IN THE UNITED STATES PATENT AND TR (Case No. RA043D2C6C2	
	•	,
In the	Application of:	)
	FARMWALD ET AL.	)
Serial	No: Continuation of 09/629,497	) )
Filed:	Herewith	)
Title:	MEMORY DEVICE HAVING A PROGRAMMABLE REGISTER (As Amended)	) )

#### PRELIMINARY AMENDMENT

## REQUEST TO APPROVE DRAWING CHANGES

FIG. 16

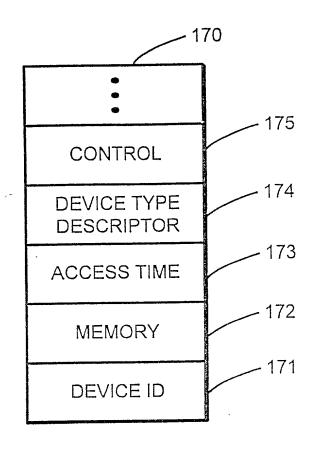
New Figure 16 is added to illustrate, among other things, access-time register(s) 173. Figure 16 illustrates one embodiment of the internal registers within each device illustrated in Figure 2. Support may be found in the specification at page 14, lines 3-21 and page 53 lines 4-21. No new matter has been added.

Attached hereto is new Figure 16. Figure 16 illustrates the internal registers which reside in each device illustrated in Figure 2. This embodiment is described in the specification at page 14, lines 3-21 and page 53 lines 4-21. No new matter has been added.

--Figure 16 is a block diagram representation of a set of internal registers within each device illustrated in Figure 2.--

FIG. 10

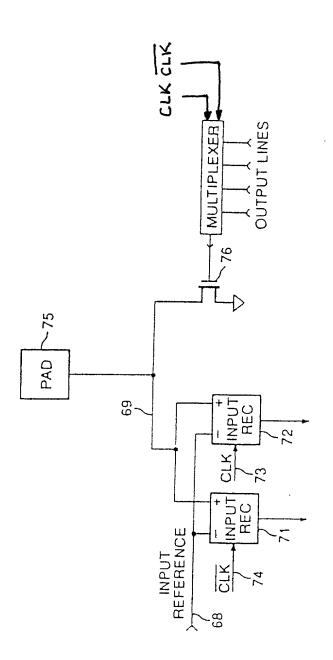
Applicants seek to amend Figure 10 to more fully reflect the discussion in the specification, in particular, page 55, lines 12-16 and page 58, lines 13-23. The proposed changes are indicated in red. No new matter has been added. Applicants respectfully request that the Examiner approve the proposed changes to Figure 10. A new Figure 10 which incorporates the changes is also attached to the Request.

Applicants seek to amend Figure 10 to more fully reflect the discussion in the specification, specifically, page 55, line 12-16 and page 58, lines 13-23. Also attached, is a photocopy of Figure 10 with the proposed changes indicated in red. No new matter has been added.

Applicants respectfully request that the proposed new Figure 16 be approved by the Examiner. Applicants also respectfully request approval of the proposed changes to Figure 10. A new Figure 10 which incorporates the changes is also attached hereto.
